Answers to review comments CBM-TRD

Simulated SPADIC2.1 shaper output for charge injections of 0 ... 100 fC in 10 fC steps. The left simulation shows the 'high gain' setting, the right the 'low gain'.

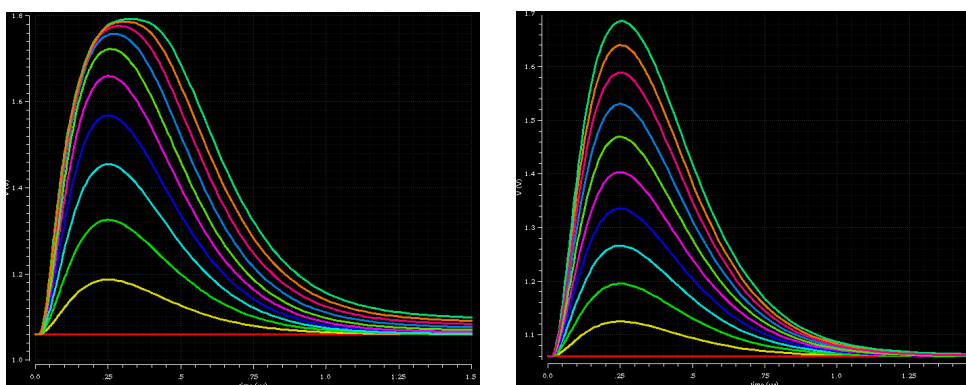
For the SPADIC specification, a Q_{max} of 75fC is quoted. The full linear range of the analog fronted should be measured and presented.

SPADIC2.1 has two selectable gain settings, 'low gain' and 'high gain', which differ by a factor 2. The simulations below show the shaper output for input charges of 0 to 100 fC in 10 fC steps for both cases. As it can be seen, the 'low gain' mode is linear up to nearly 100 fC. Measurements on SPADIC2.0 are presently being set up and results will be ready soon.

Simulated response of Charge Amplifier (bottom) and shaper (top) for a large ‘overload’ charge of 10/100/100/10000 fC followed by a 10 fC signals.

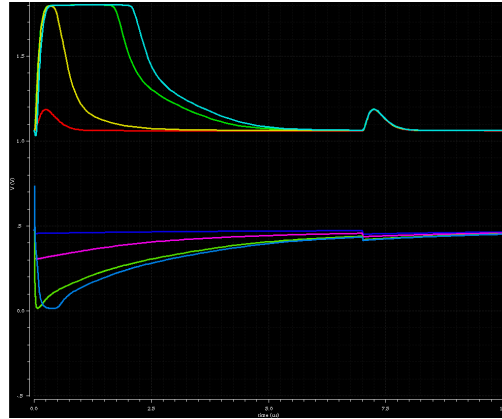
The reaction of the frontend to highly ionizing events of 10, 100, 1000x the average charge should be measured and studied. The recovery time of the shaper output is one measure of the related dead time. By injecting a sequence of very large and small pulses one can assess whether the preamp shows saturation and dead time that would not be visible at the shaper output.

SPADIC2.1 includes a nonlinear element in the feedback path of the preamplifier to discharge the input node faster for large charges compared to the normal feedback path. The simulation below shows the responses of preamplifier and shaper to an 'overload' charge of 10/100/1000/10000 fC followed after 7 μ s by a normal signal of 10 fC. This shows that the simulated overload recovery time is in the order of 5 microseconds. Note that this time depends on the various bias settings, in particular the CSA feedback current.

Measurements on SPADIC2.0 are presently being set up and results will be ready soon.

Preamplifier (bottom) and shaper output (top) for a 10 fQ charge for no and 2 nA leakage current.

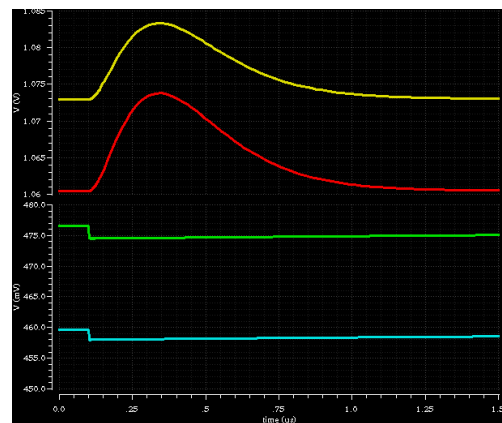
It should also be verified whether the preamp/shaper stays in the operational regime for the effective persistent input current represented by the actual charge that is flowing onto the readout pad. This situation can be easily overlooked in lab tests and test beams with short spills.

The chip is intended for readout of an isolated cathode electrode so that no significant leakage currents are expected. No special measures have been taken in the chip to sink leakage, so that any leakage leads to a DC shift in the preamplifier and shaper signals. This is illustrated in the simulation below, where preamplifier and shaper output for a 10 fQ charge signals are shown for 0 and 2 nA of leakage current. The shift introduced by the 2 nA DC current corresponds to roughly 10 fQ of charge. This shift depends strongly on the setting of the feedback resistor bias in the CSA.

Measurements on SPADIC2.0 are presently being set up and results will be ready soon.

Simulated shaper outputs for the 'fast' and 'slow' settings: The 'fast' setting uses CR-RC shaping with a peaking time of 120 ns. The 'slow' settings adds a further RC stage so that a CR-(RC)² shaping with a peaking time of 240 ns is obtained.

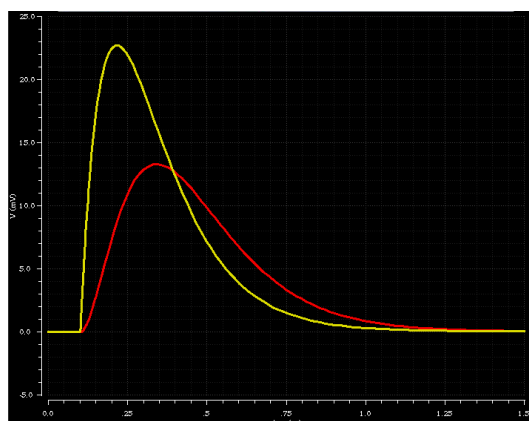
The specification of the shaping time with respect to both, Argon and Xenon, operation should be discussed.

The peaking time of the shaper signals can be changed fairly easily by exchanging passive components (Rs and Cs). This has been exercised already when moving from SPADIC1.0 (80 ns) to SPADIC2.0 (245 ns). SPADIC2.1 has a design CR-RC peaking time of 120 ns. It can be switched to a CR-(RC)² shaping with a peaking time of 240 ns, as shown in the simulation below. The ASIC designers are prepared to adjust the final shaping to the value fixed by detector scientists.
